INITIAL FIRE SAFETY INSPECTION REPORT

Factory Name: Moms Touch Sweater

RSC ID: 24691

Date: 16th May 2024

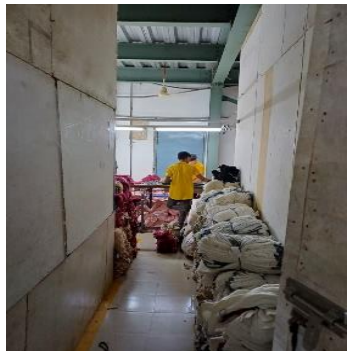
F-15	Means of Egress	Egress doors/gates with locking features not complying with NFPA101 are provided. Location: Throughout the factory buildings.	Remove locking features from all egress doors/gates. If locks are required for security reasons, utilize specialized door locking features complying with NFPA101.	Immediate
------	-----------------	--	---	-----------
